## CIRCOLARE TECNICA

MOTO GUZZI

SERIE V35 - V50 - V61 - V75

### SCATOLA TRASMISSIONE POSTERIORE

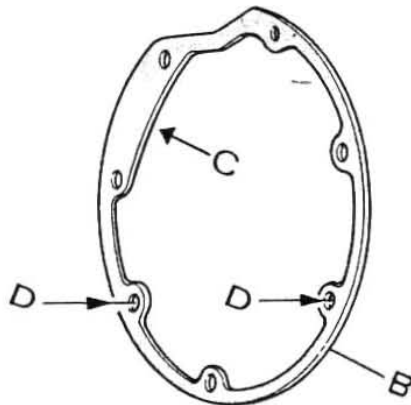
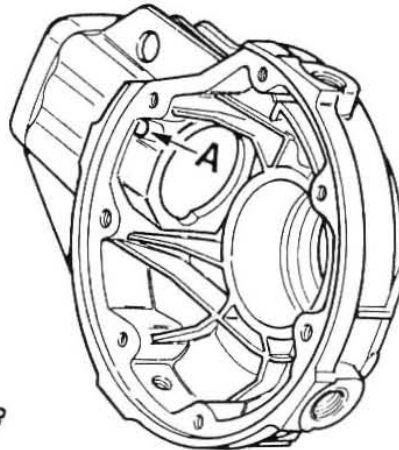
E' prevista in produzione una scatola di trasmissione che, rispetto alla precedente, presenta nervature di rinforzo particolarmente evidenti sulla parte anteriore superiore.

Su tale scatola è previsto anche un foro "A" per migliorare la lubrificazione dei cuscinetti sul pignone.

Per meglio convogliare il lubrificante nel suddetto foro, lo spessore di regolazione "B" è stato ruotato affinché la zona "C" si venga a trovare nella posizione indicata a disegno.

Per tale operazione è necessario allargare opportunamente i fori indicati dalle frecce "D".

La guarnizione di tenuta tra lo spessore di regolazione "B" e la scatola di trasmissione, dovrà essere posizionata come in precedenza (per chiudere lateralmente la camera dello sfiato).

It has been put in production a transmission housing which differs from the previous one for the stiffening ribs specially on the front upper part.

On the transmission housing it is located an hole "A" to improve the lubrication of the driving pinion bearings.

To improve the oil convey trough the above mentioned hole, the spacer "B" has been turned, so that the "C" area is situated in the position which is shown in the drawing.

To carry out this operation it is necessary to widen the holes shown from the arrows "D", in a suitable manner.

The gasket between the spacer "B" and transmission housing would be placed as before, in order to seal sidewise the breather chamber.
